Tender Ref: TPCODL/P&S/1000000394/2023-24

Sub: Corrigendum to open tender number TPCODL/P&S/1000000394/23-24, Rate Contract for Supply of HG Fuse .

**Revision-01**

Specification Name: Specification for 11kV 200A HG

# 19. Drawing (reference for tender purpose only)

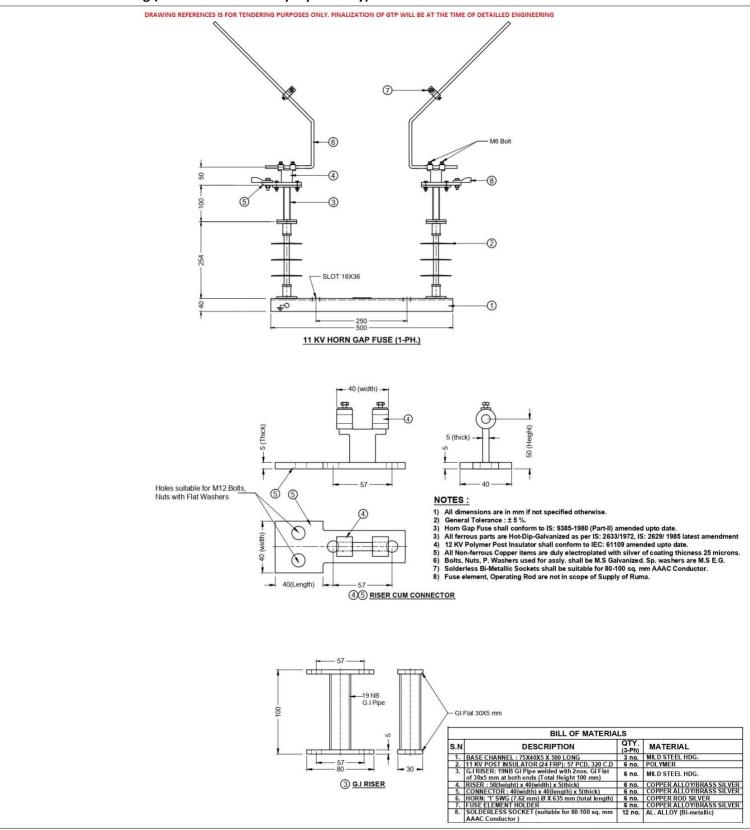
FORMAT F.1				
Format for Query	/ Clarification / Deviation (QCD)			
Tender No :	TPCODL/P&S/1000000394/23-24			
Package Name :	Rate Contract for Supply of 11kV & 33kV HG Fuse			
Note :				
				T
Sr. No.	Detailed Reference to concerned Document . Please specify Document No / Clause No / Page No	Description as per Bid Document	Query / Clarification / Deviation	TPCODL Response
1	2	3	4	5
1	Page no.132 , SI no.18	Aluminium Strip for HG Fuse	Aluminium Strip for HG Fuse is NOT REQUIRED in HG Fuse supply.	Not req.
2	Page no.133, Si no.22	Riser Unit (150 mm height total) -  (i) The shape of connectors may be made out of straight copper Flat.  (ii) Copper Riser 40 mm width x 5 mm Thick x 80mm height.  Copper Connector 40 mm width x 5 mm thick x 40 mm length.  (iii) All Nonferrous parts shall be silver plated with coating thickness of (25 microns min.)  b) 100 mm height G.I Riser made of 19 mm nominal bore medium gauge G.I pipe welded with 2 nos. of G.I flat of 30mmx5mm of both ends fixed with 10mm dia. bolts and nuts with flat & spring washer. All the bolts, Nuts and washers should be made out of Brass.	(ii) Kindly clear the difference between the Copper Riser & Copper Connector with its dimensions.  (iii) Kindly allow the coating thickness of	ii. Refer drawing for ENG-HV-2021-R01 iii. 25 Microns
